ADDENDUM NO. 0

Date: May 11, 2022

Project: **SCUSD Project No. 454-1**
Shade Structures Group 1A

DATE: 04/29/22
 PROJECT NO.: 21-1504.04
 SHEET:
AD0.01

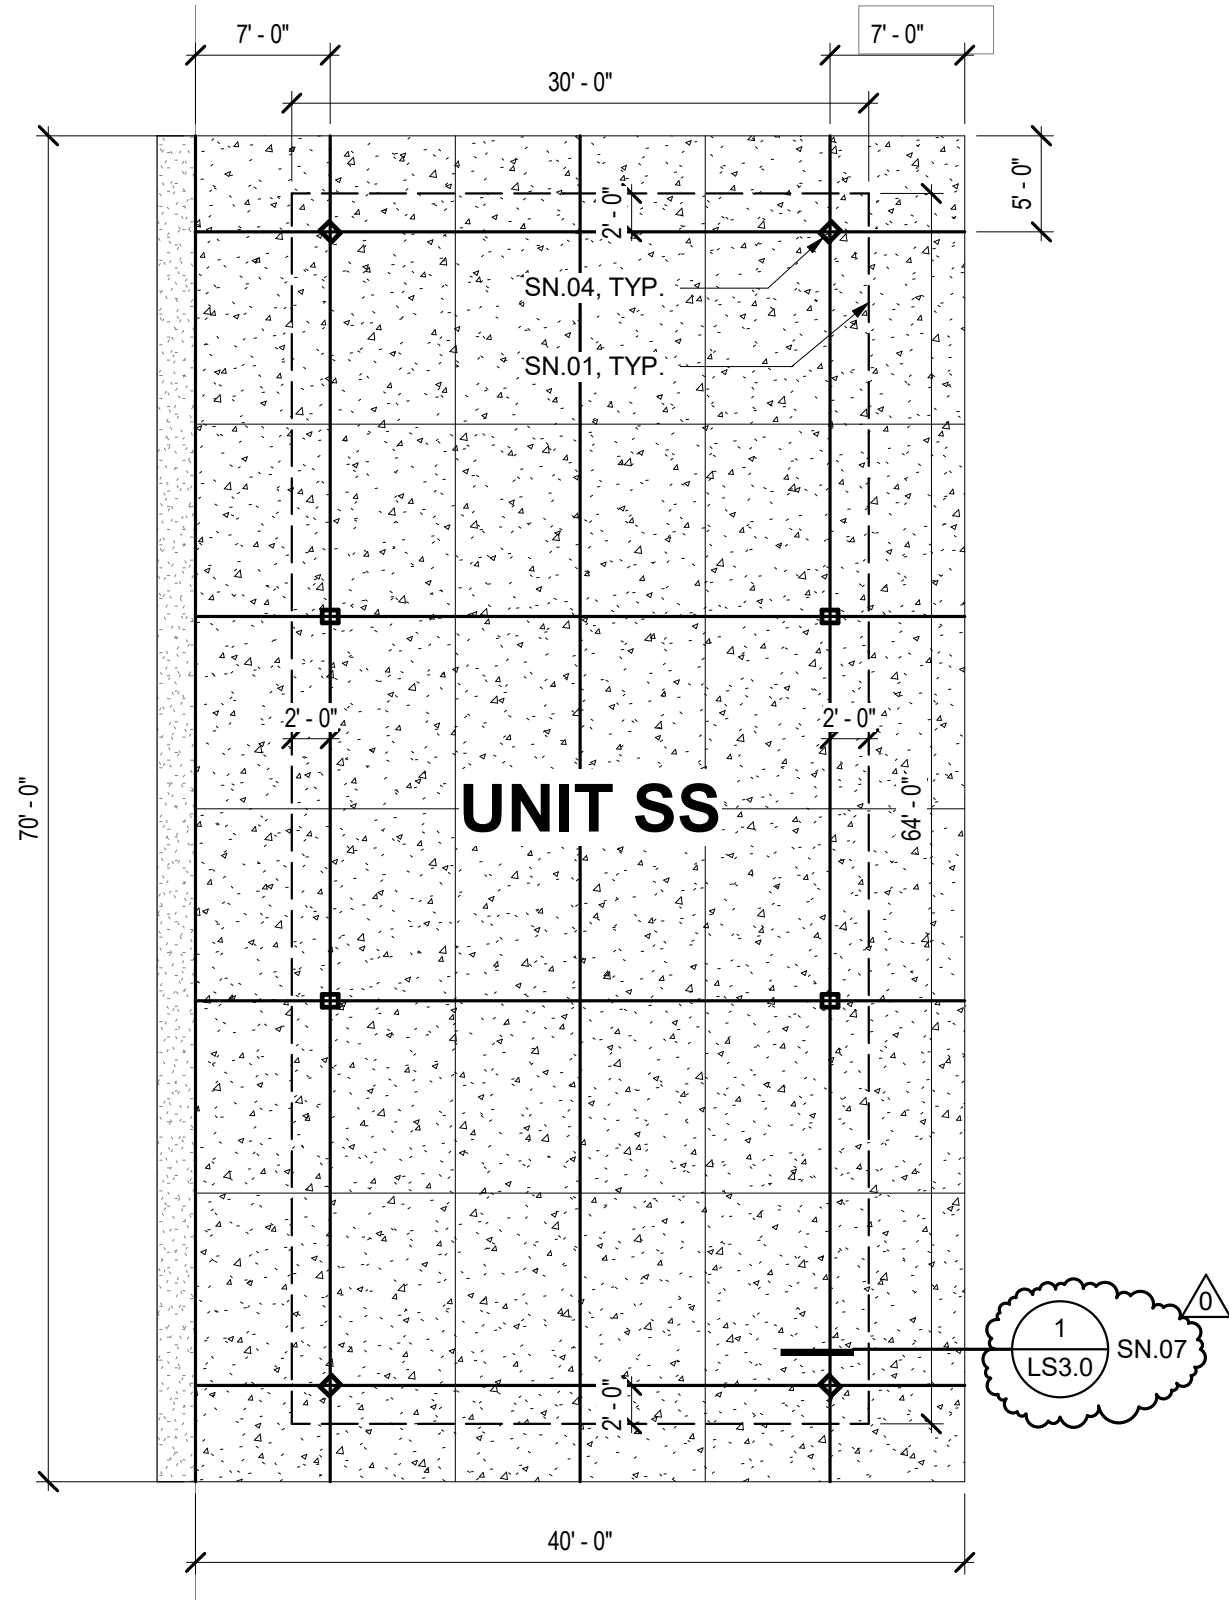
- A. Sheet A0.2, Typical Mounting Heights and Details
 - 1. Detail 10, Hydration Station Guardrail: REVISE per sheet AD0.01 included with this addendum
- B. Sheet C0.1, Civil General Notes and Abbreviations

DATE: 04/29/22
 PROJECT NO.: 21-1504.04
 SHEET: **AD0.03**

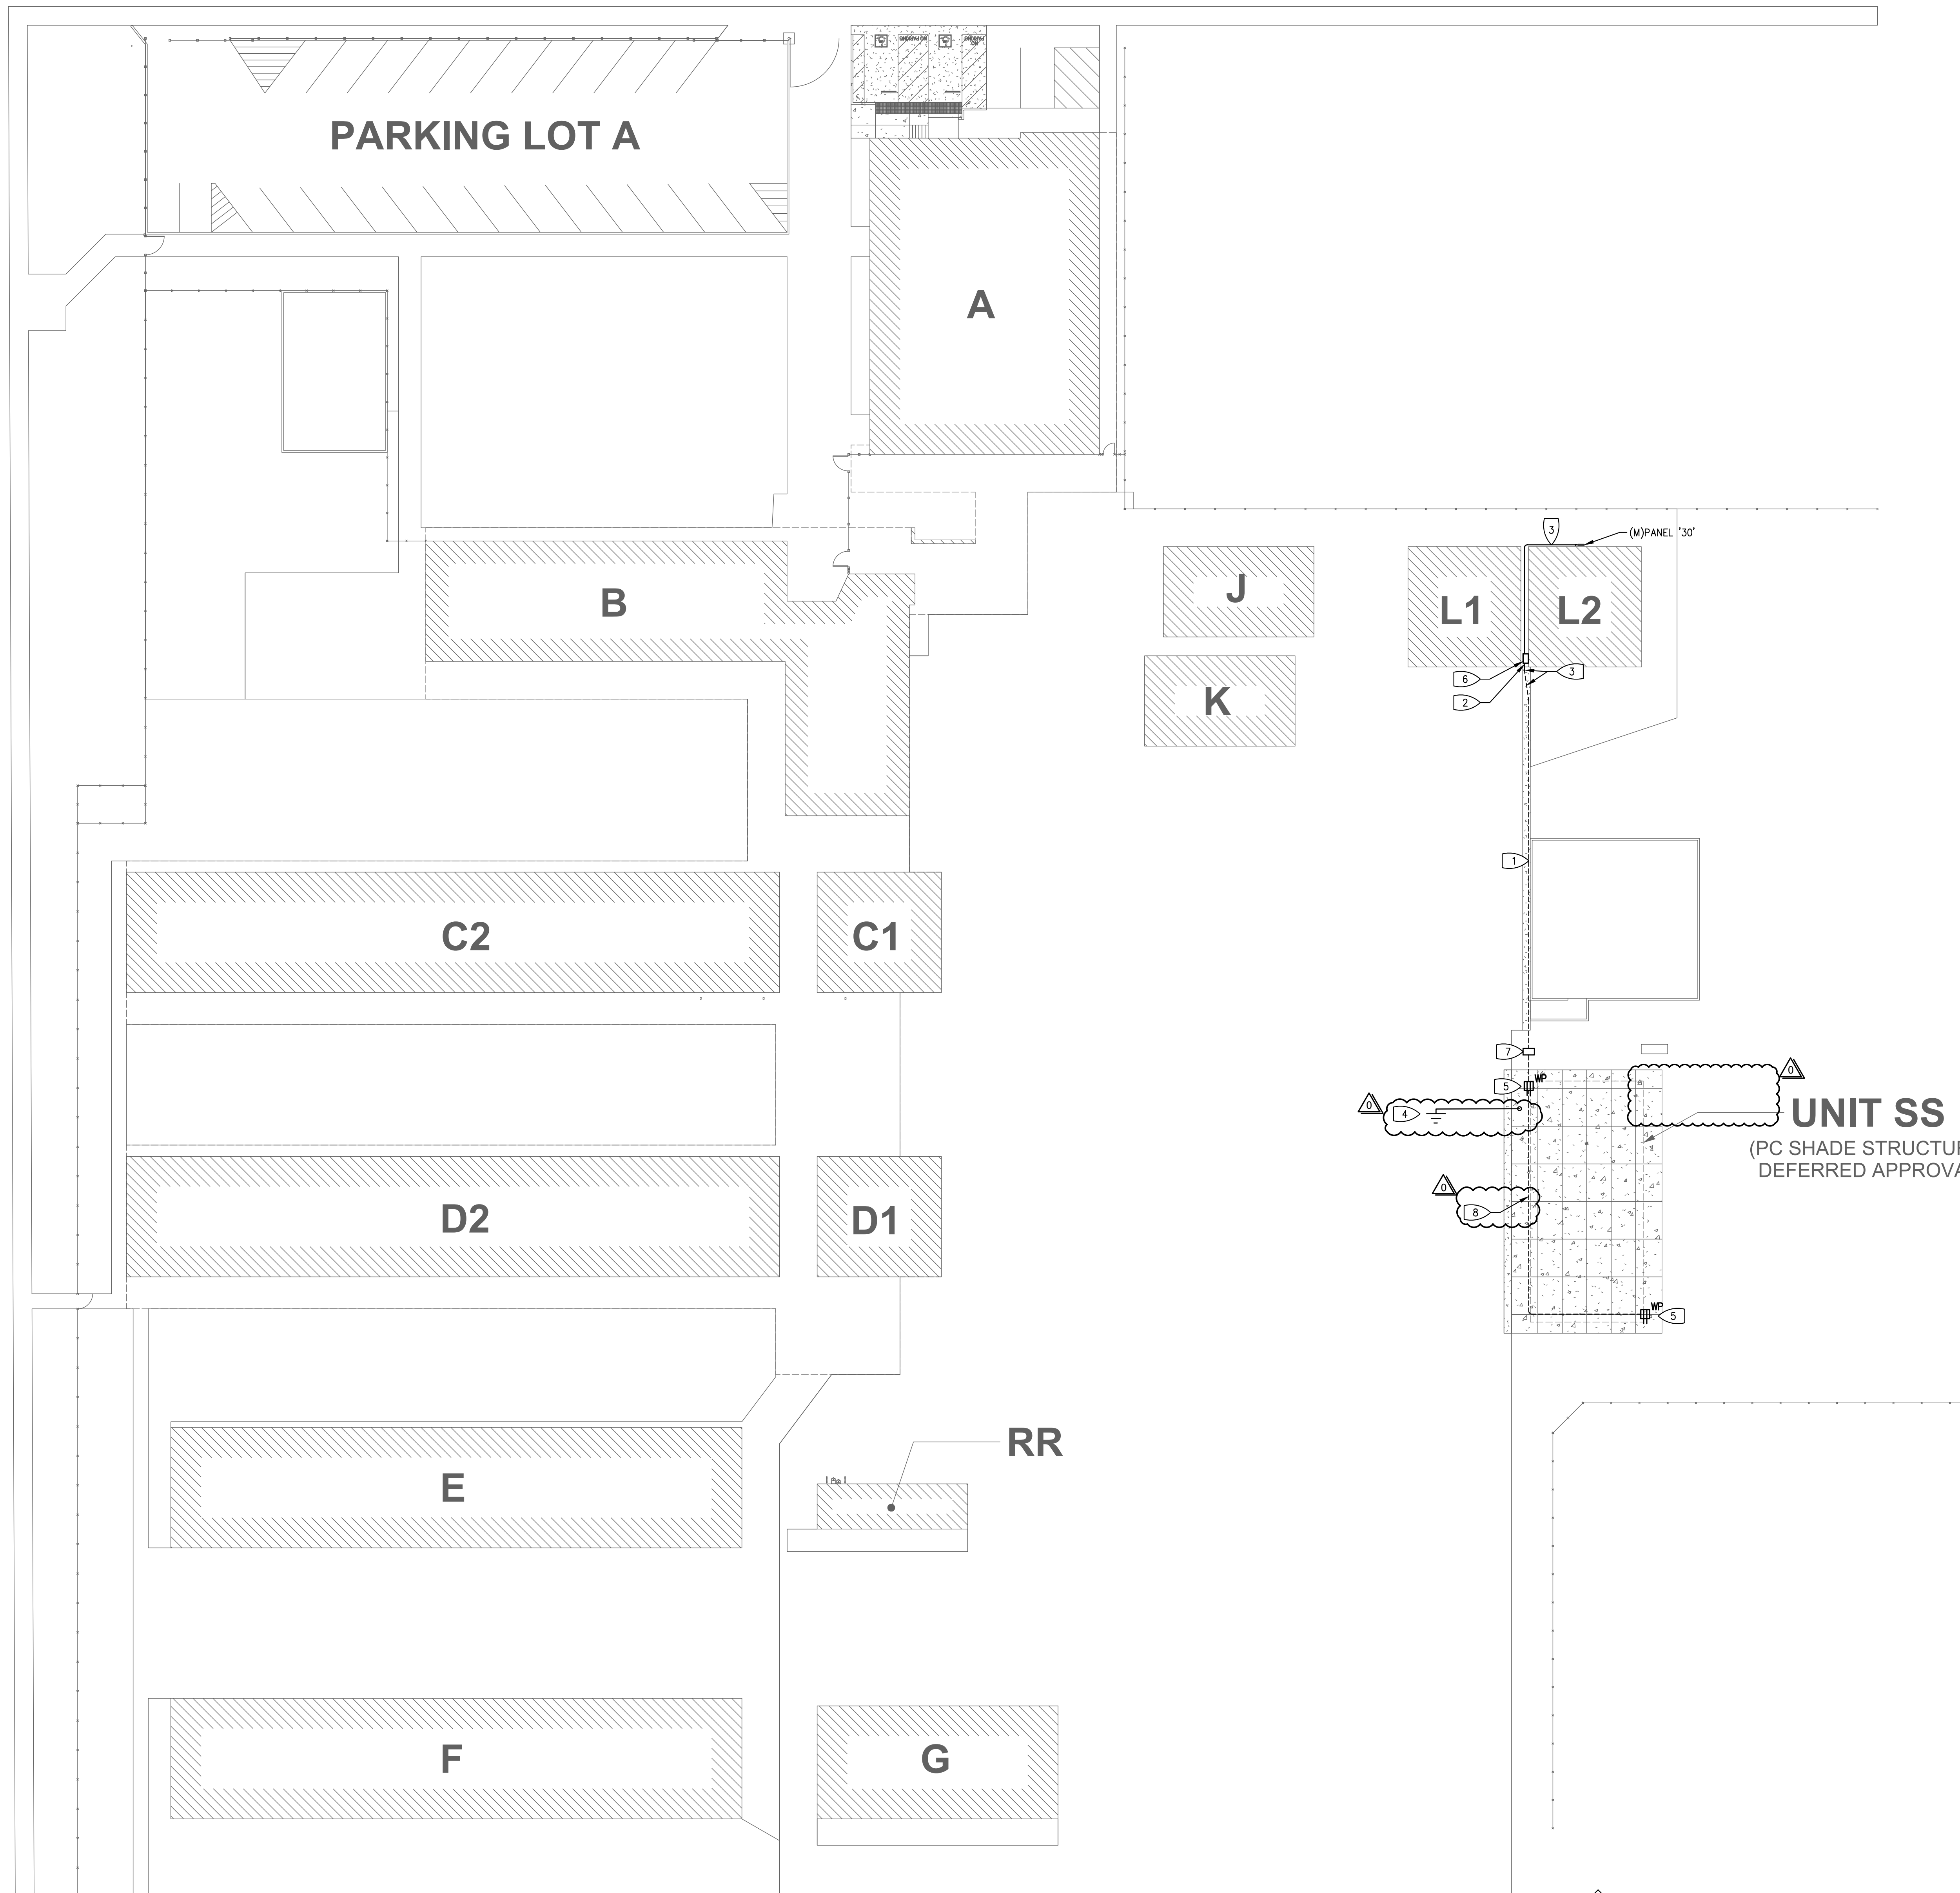
- 2. ADD Landscape / Irrigation Note per sheet AD0.02 included with this addendum.
- C. Sheet A1.1.2, Partial Site Plans and Details
 - 1. Detail 1, Enlarged Site Plan - SS: REVISE site plan to now show a section callout at the shade structure column per sheet AD0.03 included with this addendum.

- 2. Sheet Note 7: ADD note. Text to read "For footing / concrete pad / column interaction, see PC shade structure / deferred approval"
- D. Sheet E1.1, Site Plan - Electrical

PROJECT NO. 21-1504.04
 DATE: 04/29/22
 SHEET E3.1

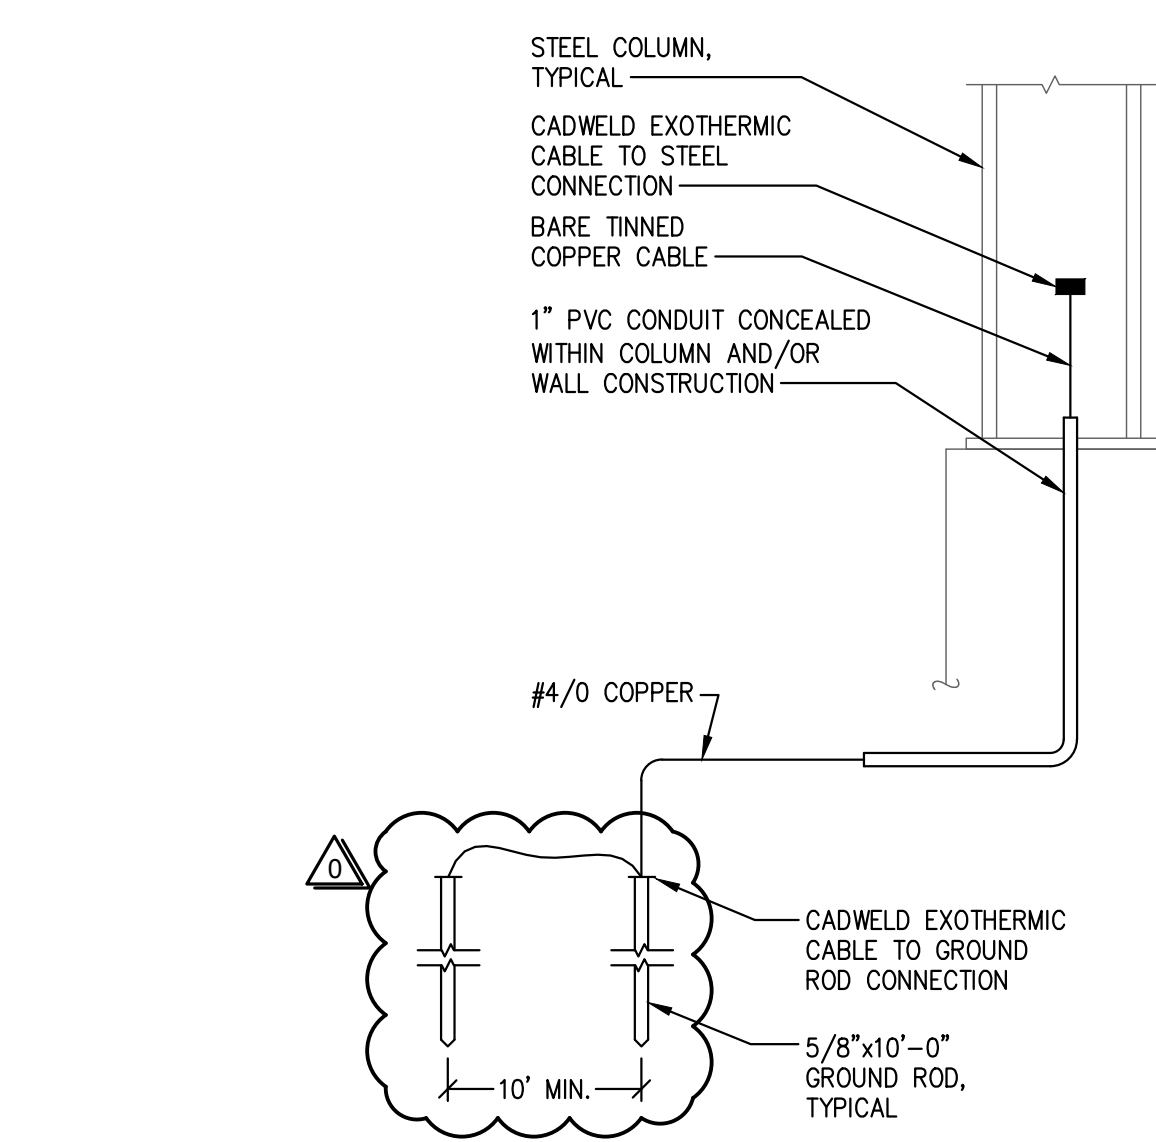
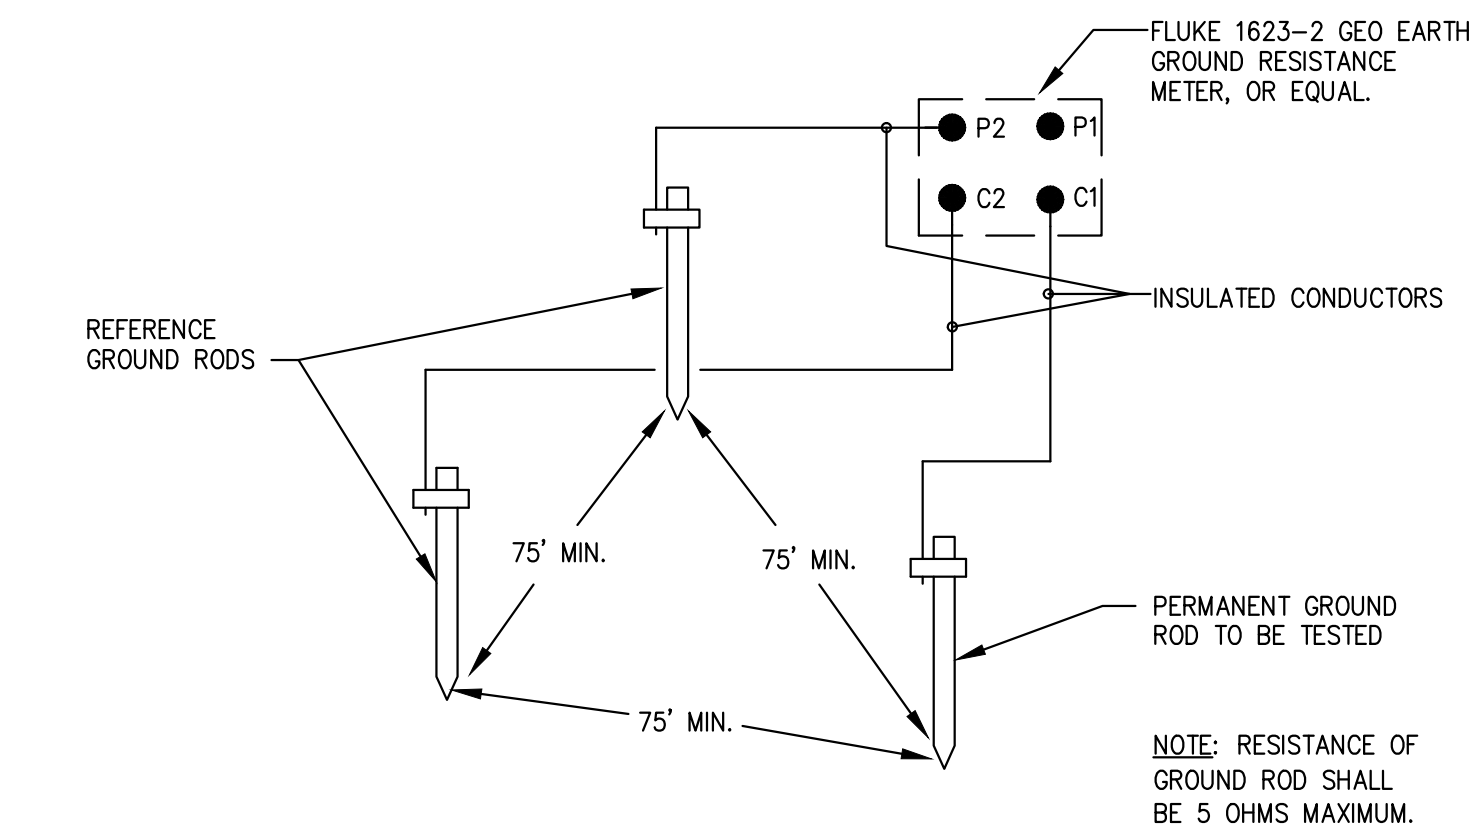
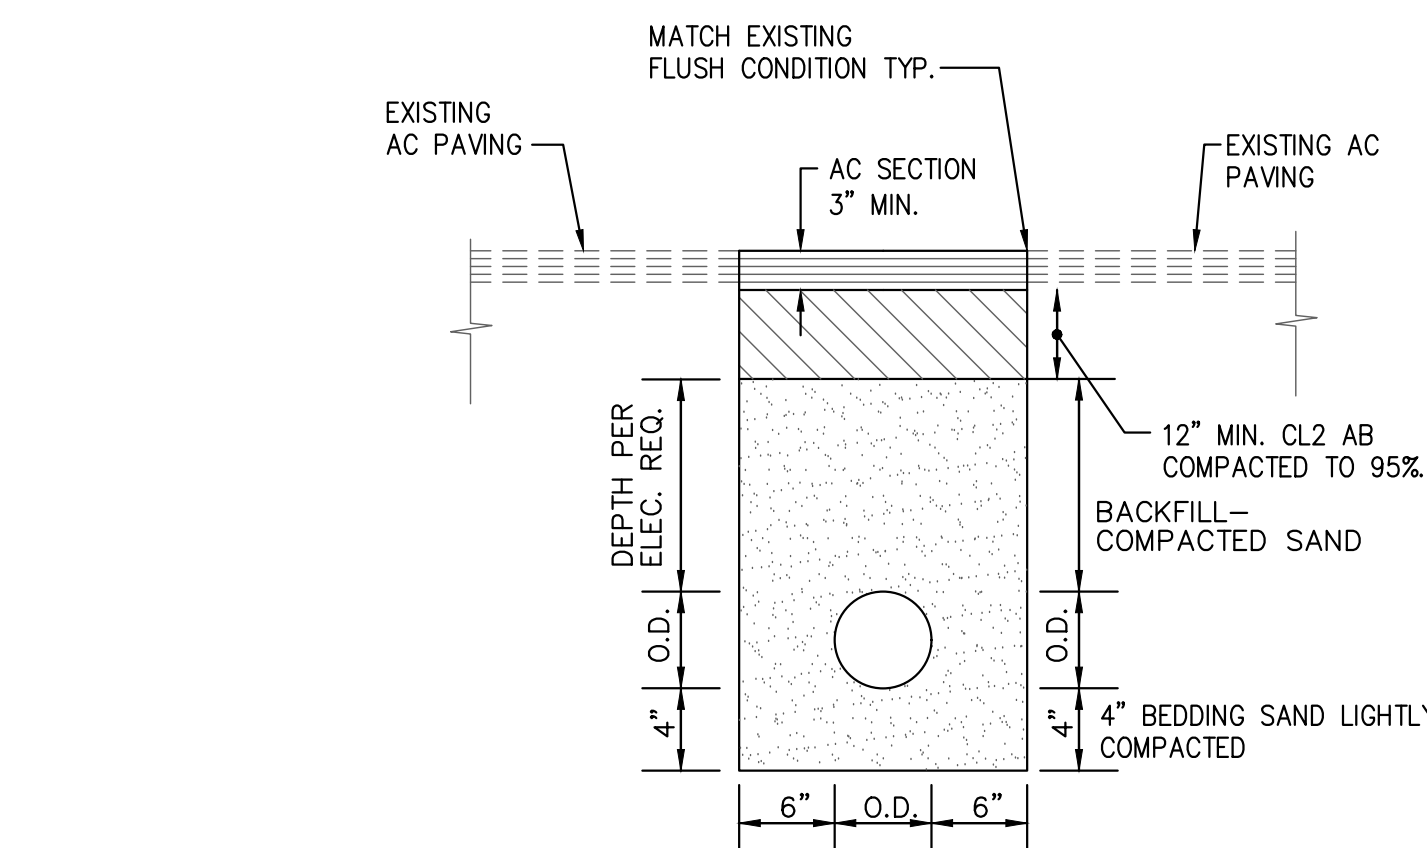
1. Detail 2, Typical H/20 Traffic Rated Pull Box: REVISE per sheet AD0.05 included with this addendum.
 2. Detail 4, Conduit Stub in Post Detail: REVISE per sheet AD0.05 included with this addendum.

3. Detail 5, Typical Steel Column & Rebar Grounding Detail: REVISE per sheet AD0.05 included with this addendum.
- F. Sheet 2, Statement of General Conformance
